June 4, 2019
IDEA PUBLIC SCHOOLS – IDEA Palmview Phase I

ADDENDUM NO. 1

A. PURPOSE AND INTENT
This addendum is issued for the purpose of modifying the plans and specifications for the IDEA PUBLIC SCHOOLS – IDEA Palmview Phase I

Date:	2019
Scale:	As Noted
Project Architect:	David Monreal, AIA
Drawn By:	RB, JA
Job No.	IDEA 2020 Phase I
Sheet:	A1.01

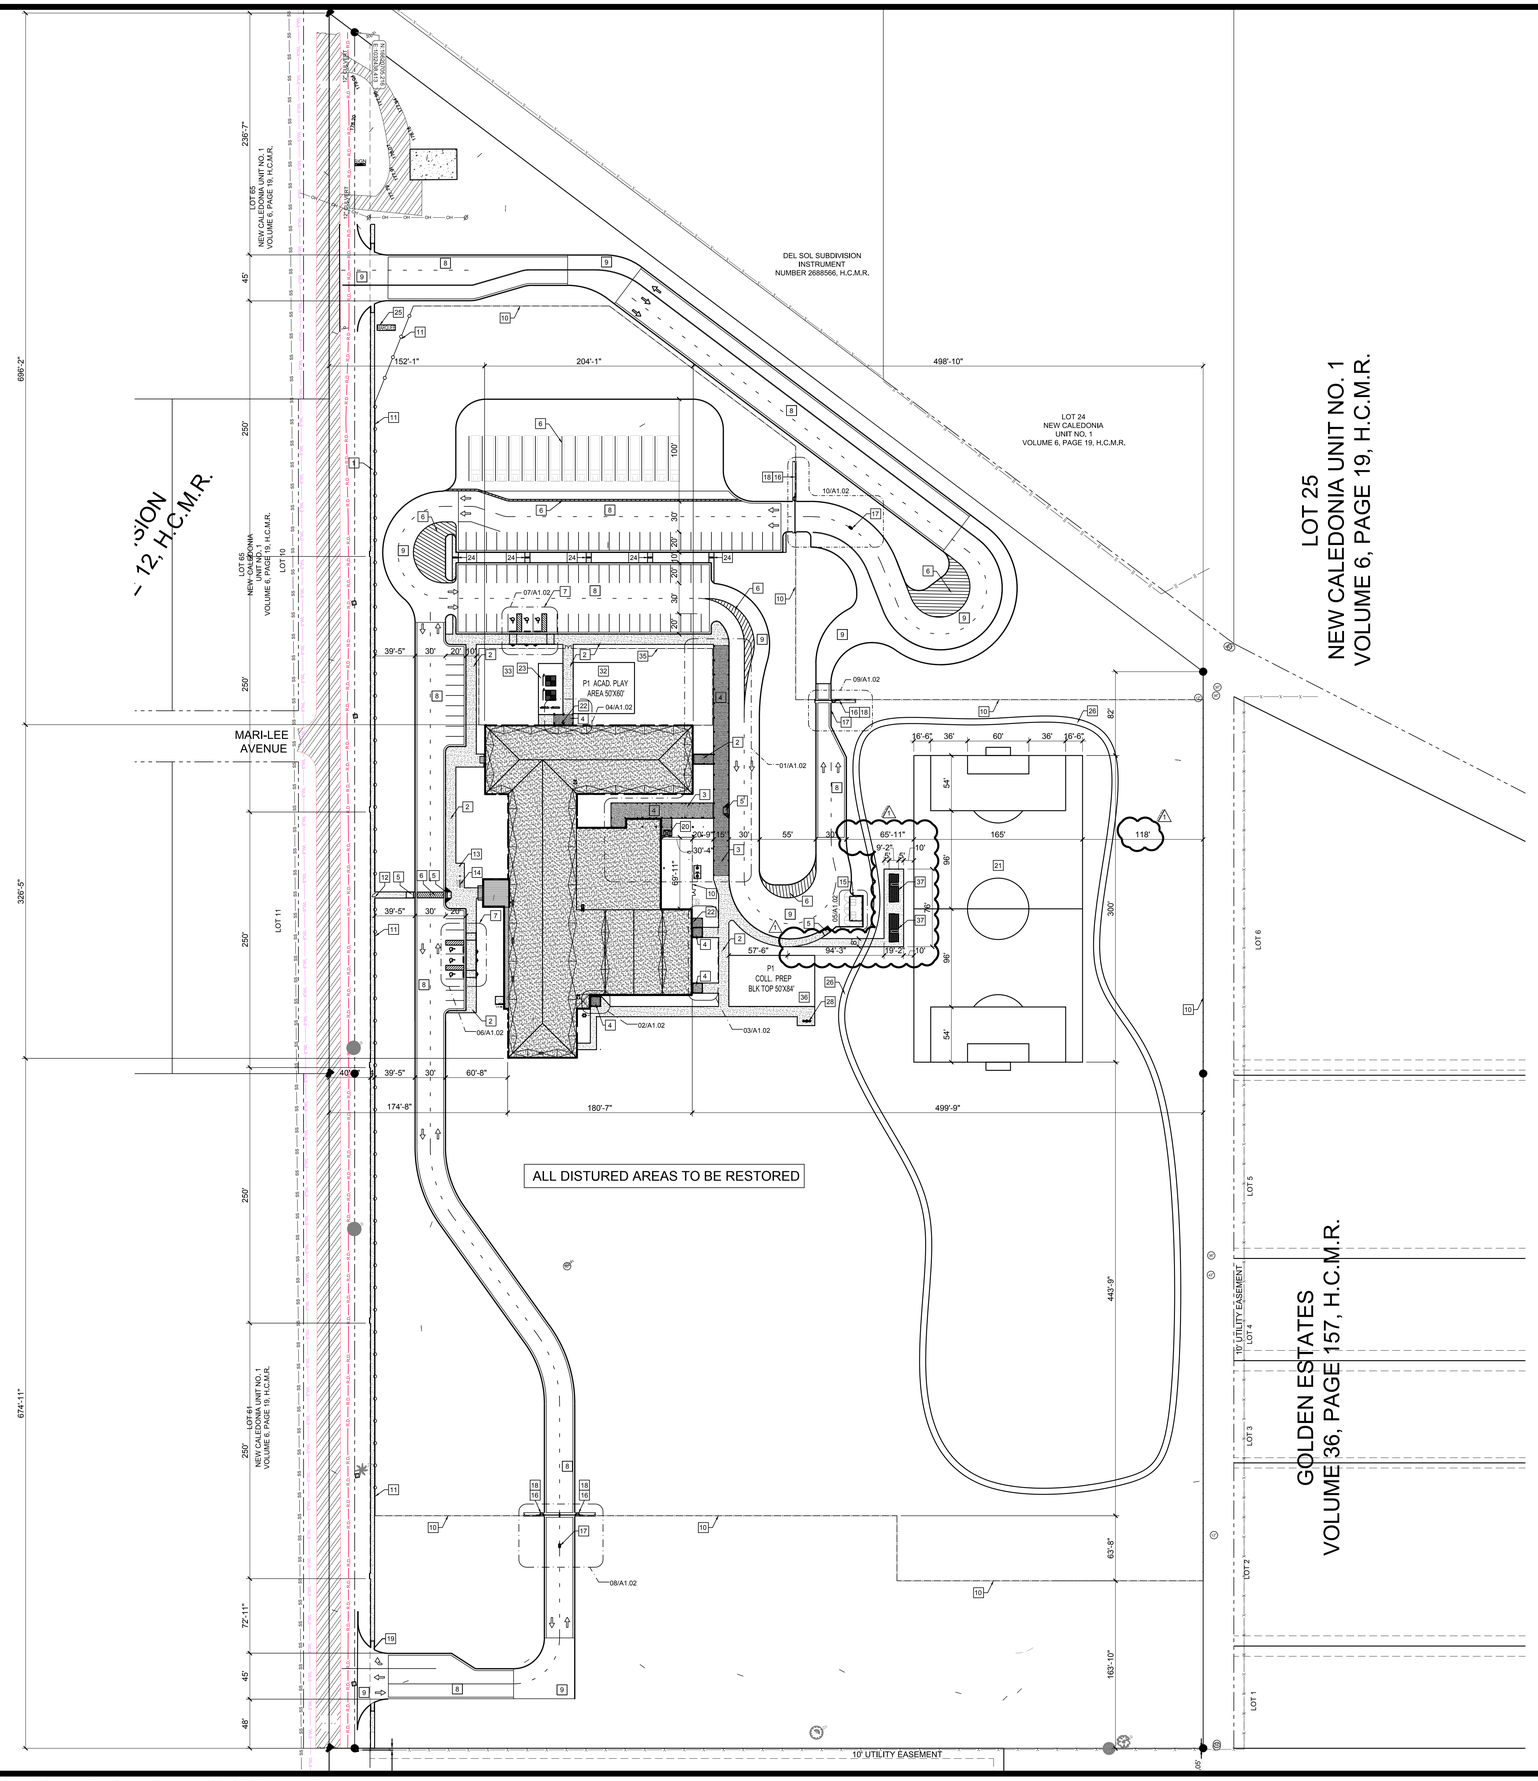
1. Sheet A1.01 – Campus Overall Plan
   a. ADD *Aluminum Bleachers on concrete pad and concrete walk to Soccer Field.* Replace Sheet A1.01 previously issued with Sheet A1.01 included in this addendum.

36. 50'X84' ASPHALT MULTI SPORT AREA REF CIVIL FOR ADDITIONAL INFORMATION
37. PROVIDE (2) -27' X 5 ROW PICKET GUARD RAIL ALUMINUM BLEACHERS, FASTEN TO CONCRETE FOUNDATION. MODEL # BGS-122 BY BELSON OUTDOORS 1-800-323-5664, WWW.BELSON.COM

01 CANOPY PLAN
SCALE: 3/32" = 1'-0"

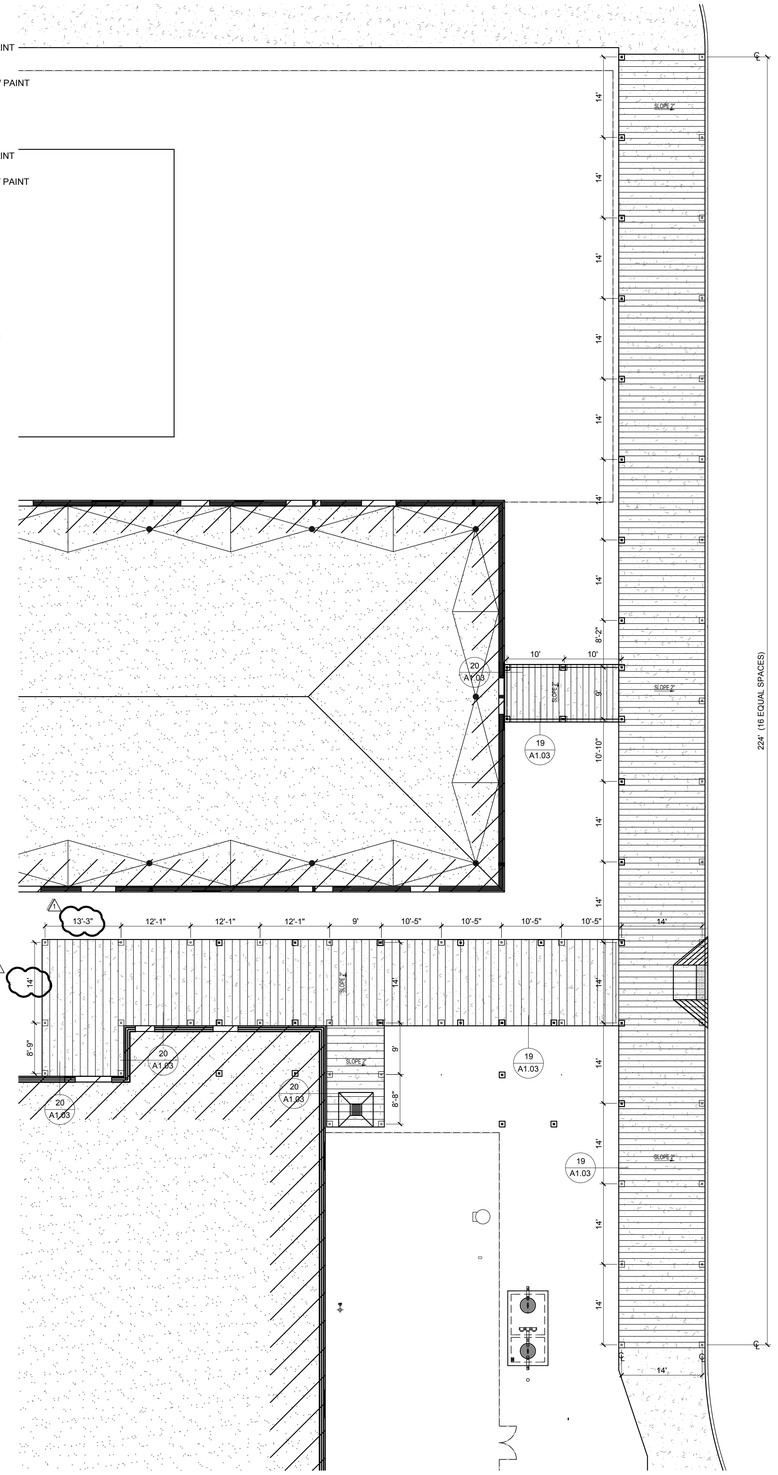
2. Sheet A1.02 – Site Details
   b. REVISE *Dimensions on Detail 1/A1.02 Canopy Plan*. Replace Sheet A1.02 previously issued with Sheet A1.02 included in this addendum.

Date: 2019
Scale: As Noted
Project Architect: David Monreal, AIA
Drawn By: RB, JA
Job No. IDEA 2020 Phase I
Sheet: CODE

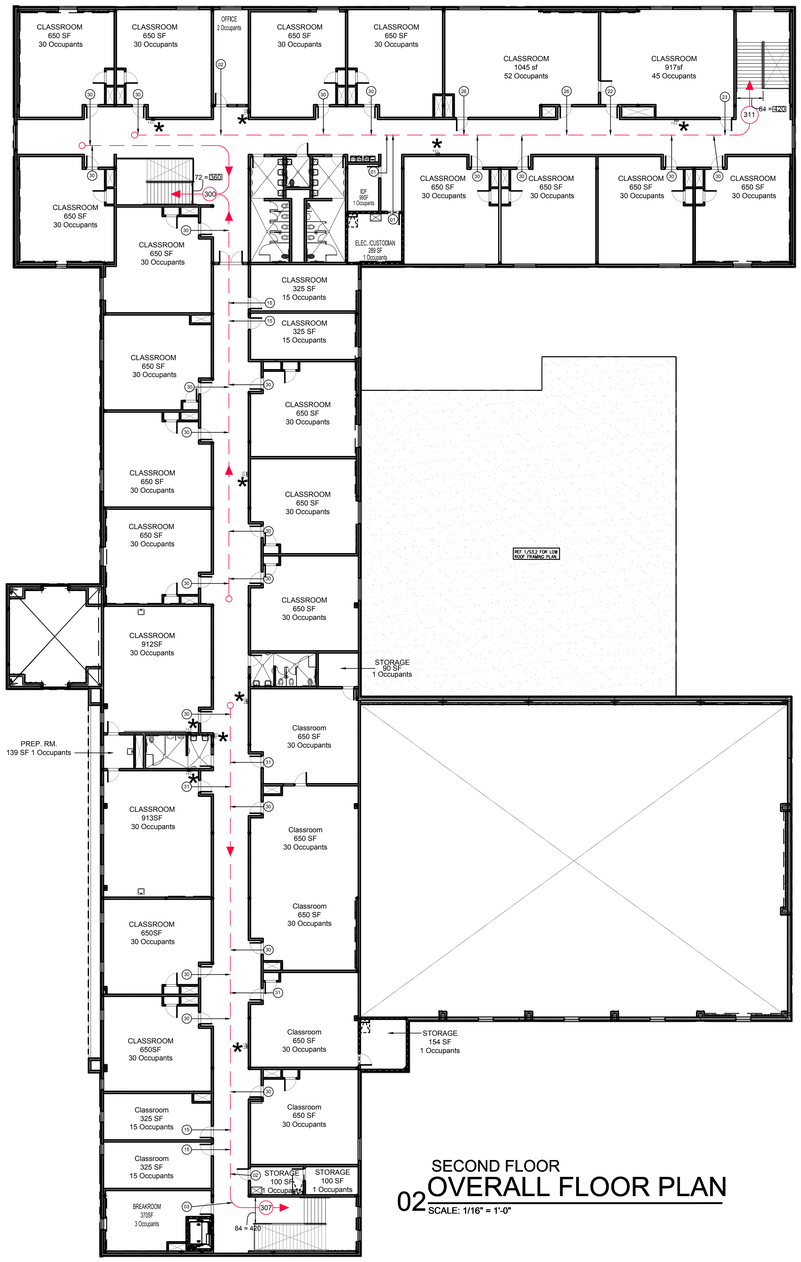
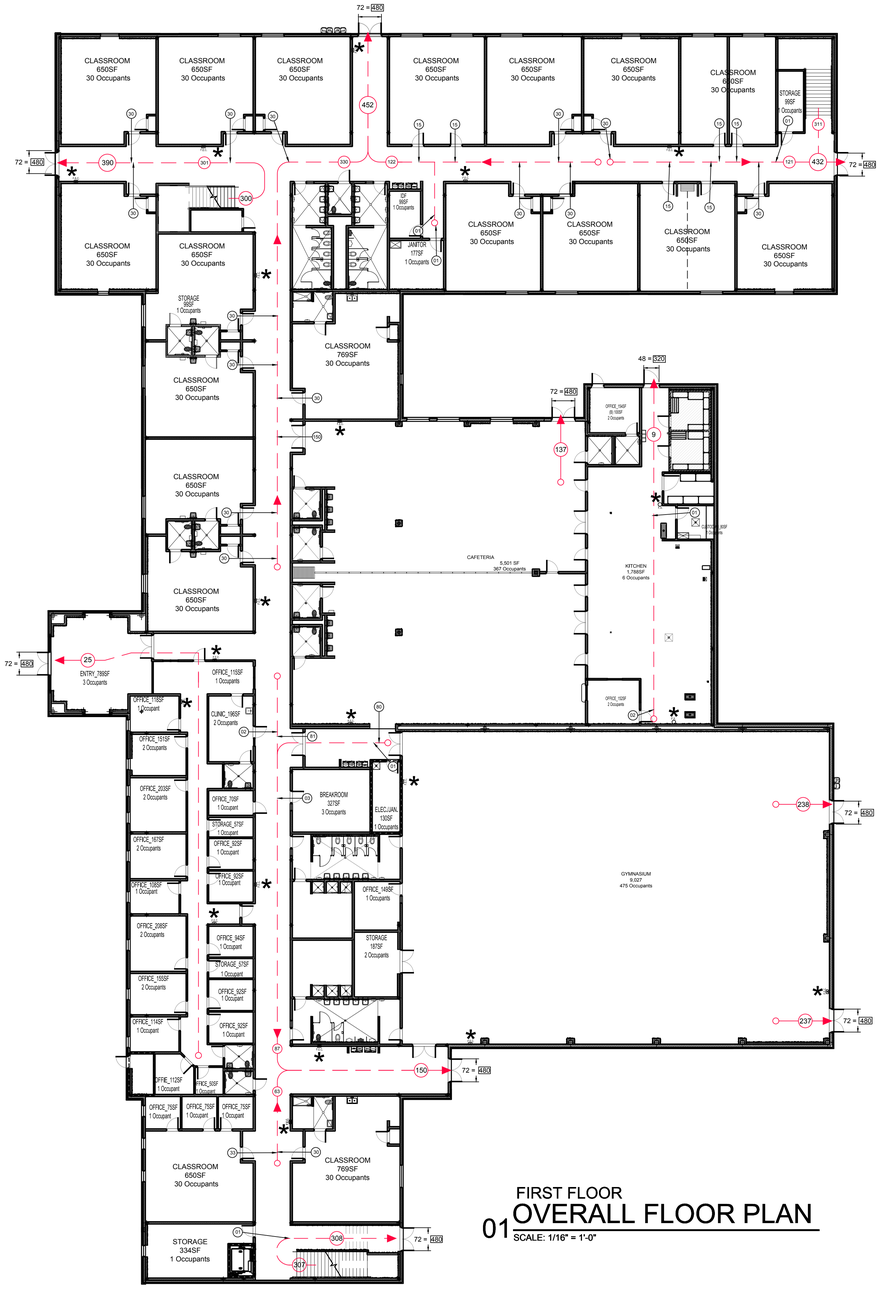
3. Sheet CODE – Code Sheet
   a. Replace sheet CODE previously issued with sheet CODE included in this addendum.
   b. Revised IBC code edition to be 2015

Date:	2019
Scale:	As Noted
Project Architect:	David Monreal, AIA
Drawn By:	RB, JA
Job No.	IDEA 2020 Phase I
Sheet:	A2.10

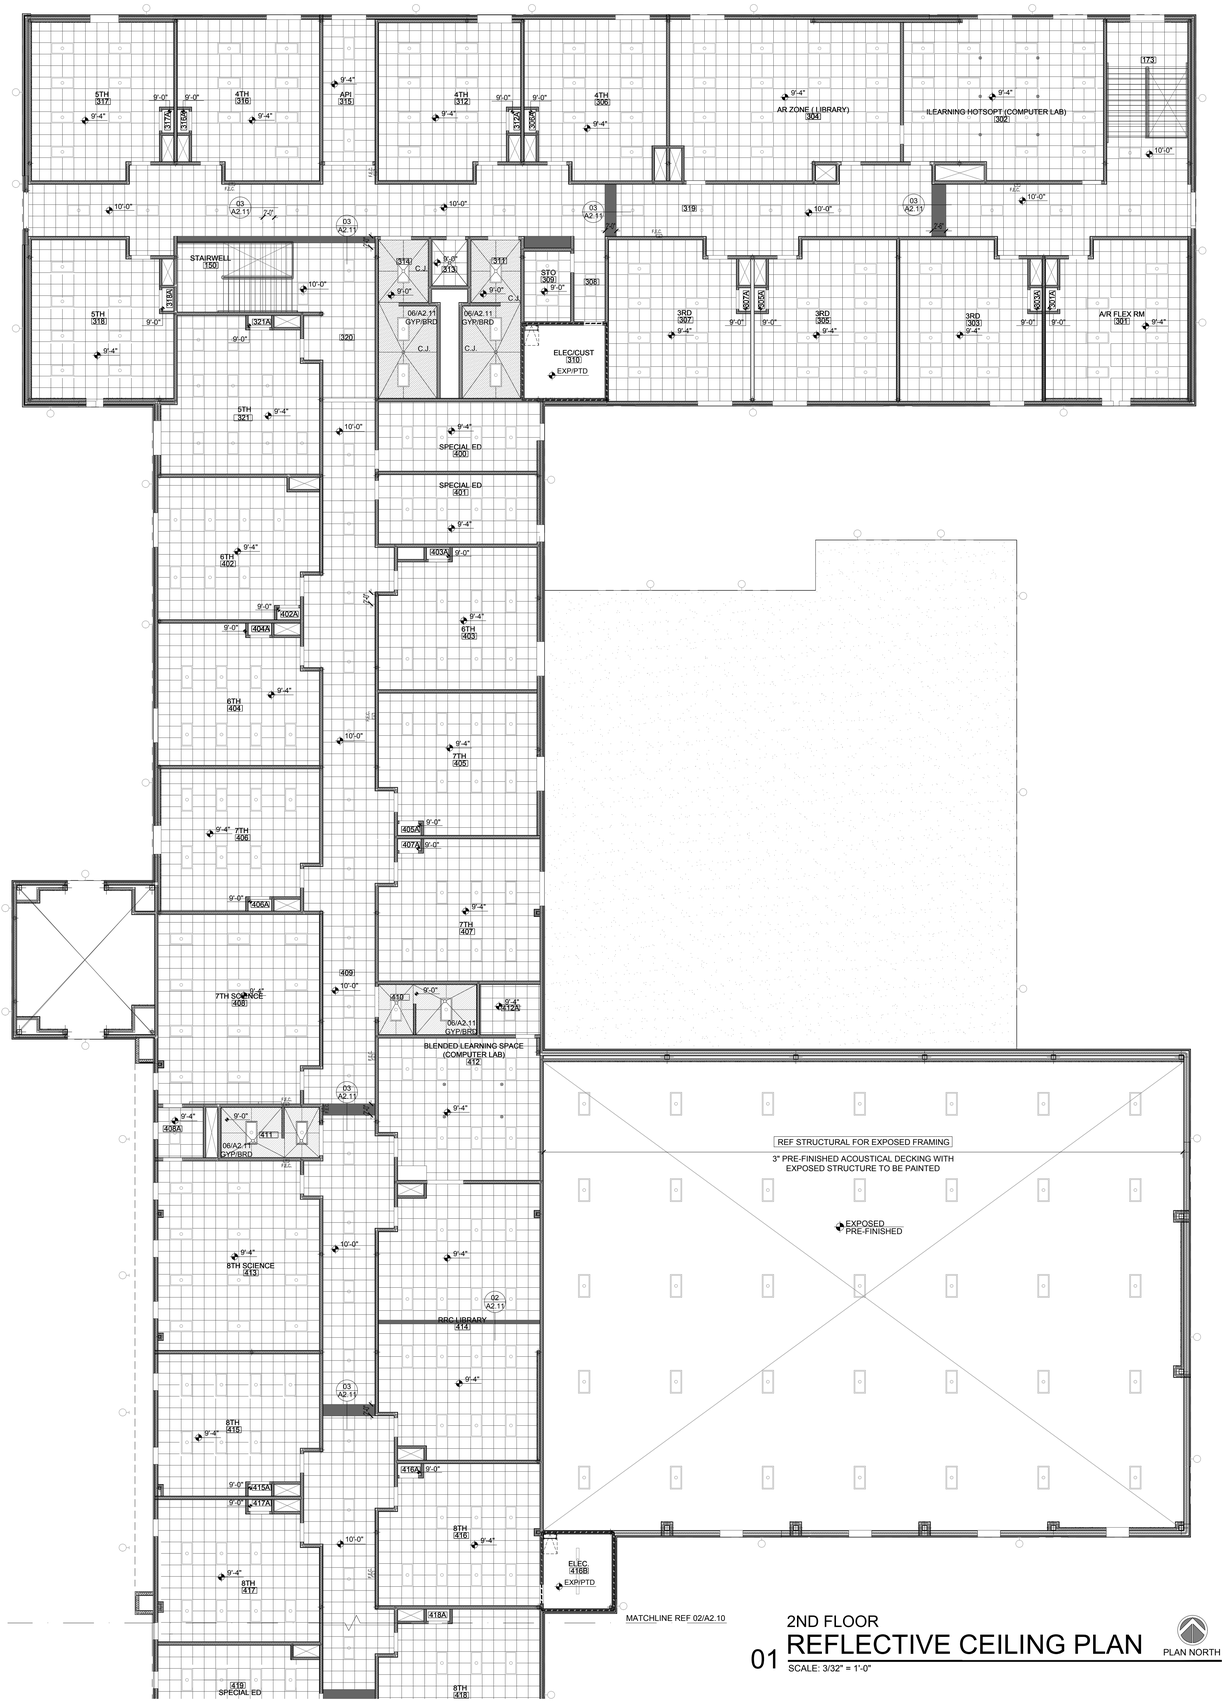
2. Sheet A2.10 – Reflected ceiling plan
   a. Replace sheet A2.10 previously issued with sheet A2.10 included in this addendum.
   b. Delete gyp/brd furr down and extend SAC @ room 421.

01 ROOF PLAN

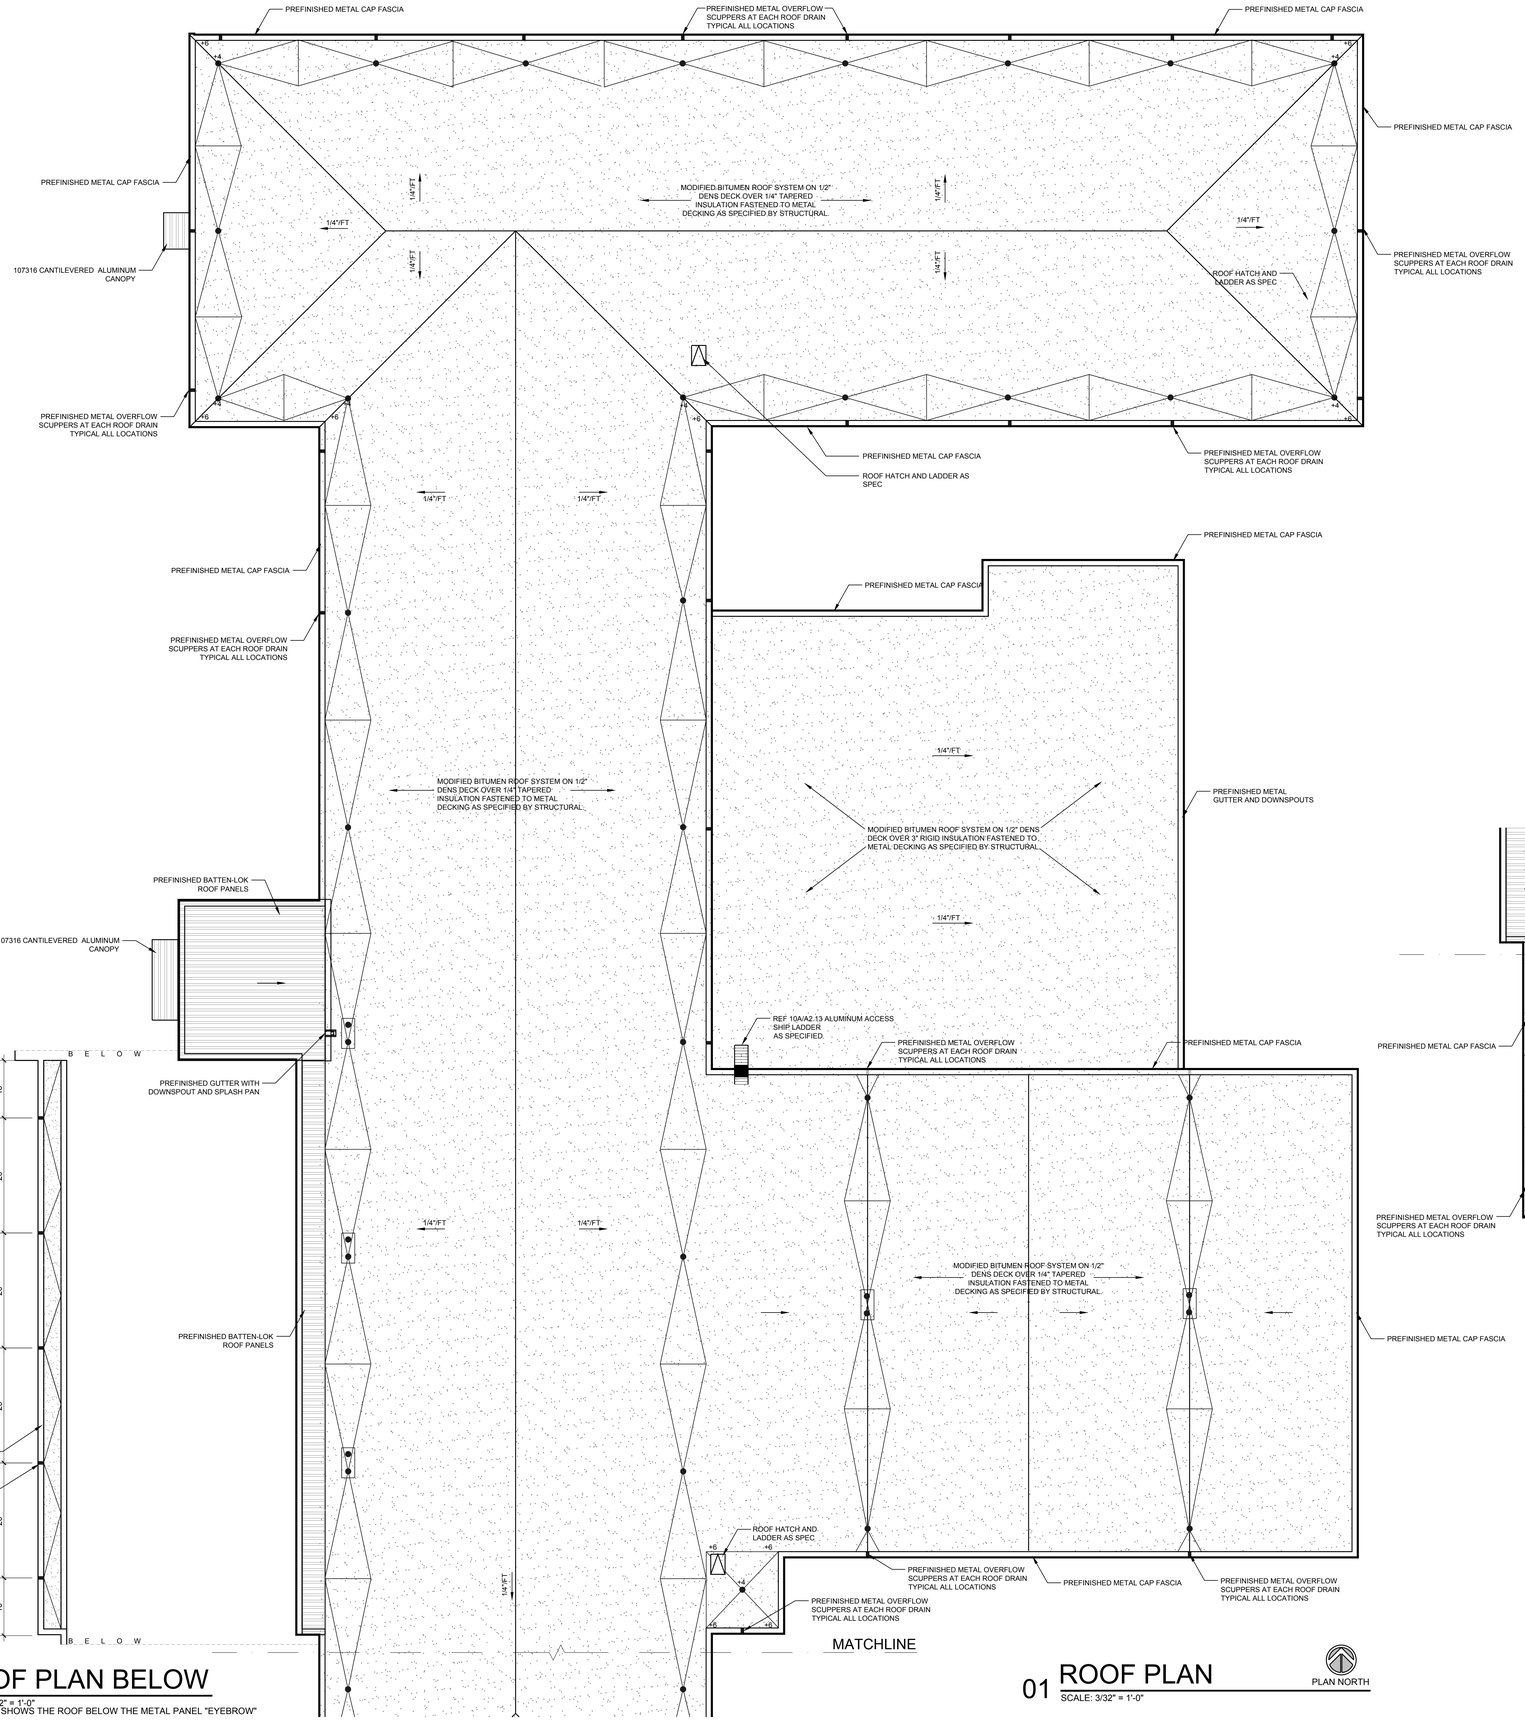
3. Sheet A2.11 – Roof plan
   a. Replace sheet A2.11 previously issued with sheet A2.11 included in this addendum.
   b. Reissued sheet shows edge of parapet (exterior building outline).
